REQUEST FOR COUNCIL ACTION

AGENDA SECTION: PUBLIC HEARINGS	ORIGINATING DEPT: PLANNING	ITEM NO E-10
ITEM DESCRIPTION: Final Plat #03-40 to be known as Harvestview First Replat		PREPARED BY: Brent Svenby, Planner

RE: Final Plat #03-40 by Bigelow Enterprises to be known as Harvestview First Replat.

HARVESTVIEW FIRST REPLAT

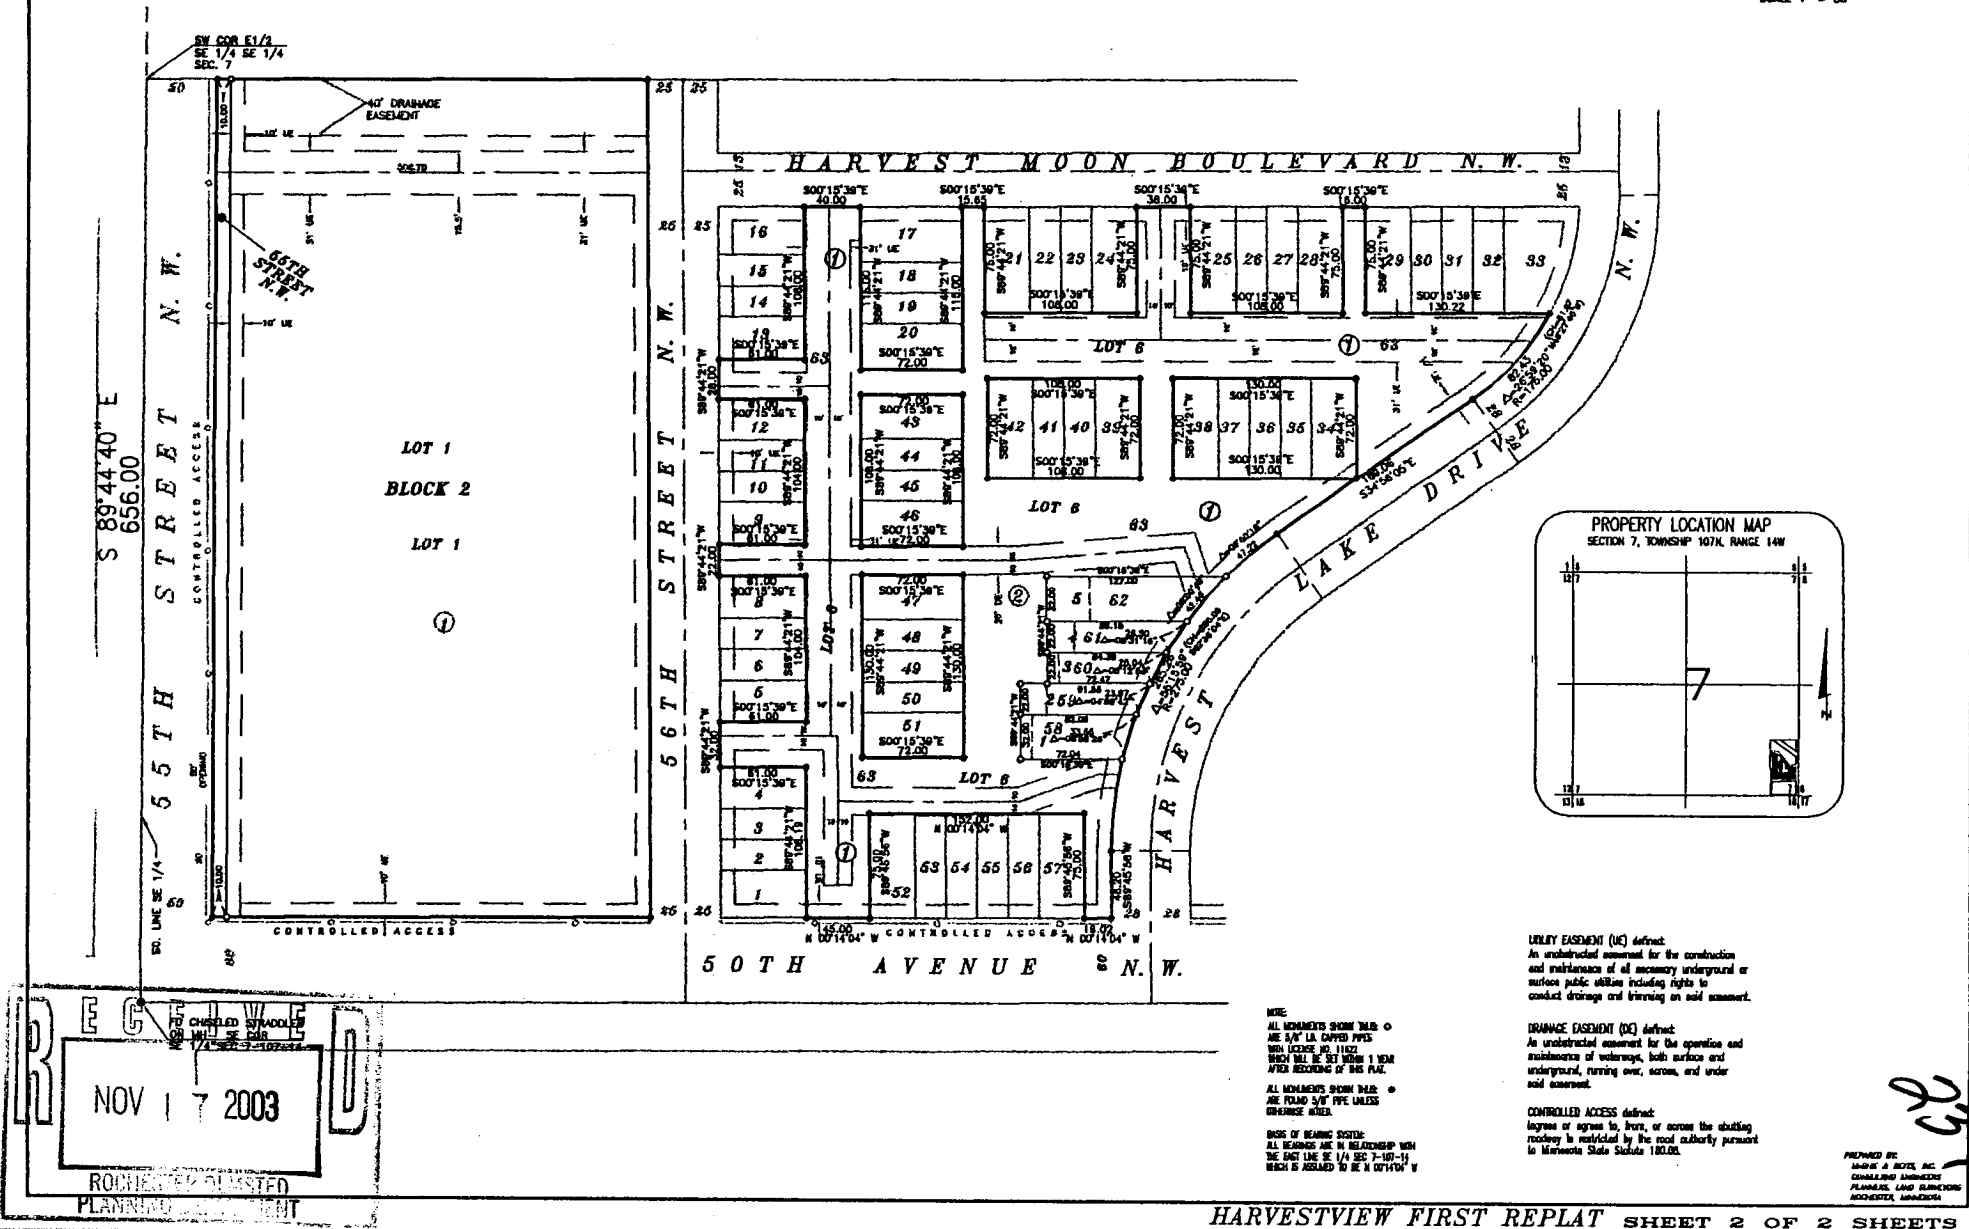
1. There is an existing Development Agreement for this Property.
 2. If proposed grading varies from the approved Grading Plan, as a result of the proposed lot line modifications, approval of a revised Grading Plan is required.
- ❖ Charges/fees applicable to the development of this property are addressed in the Development Agreement and City-Owner Contract for this Property.

1. Additional public utility easements will be required within Lot 1, Block 2 for the necessary water system improvements to serve this lot. These if not determinable at this time can be dedicated later as that area develops.
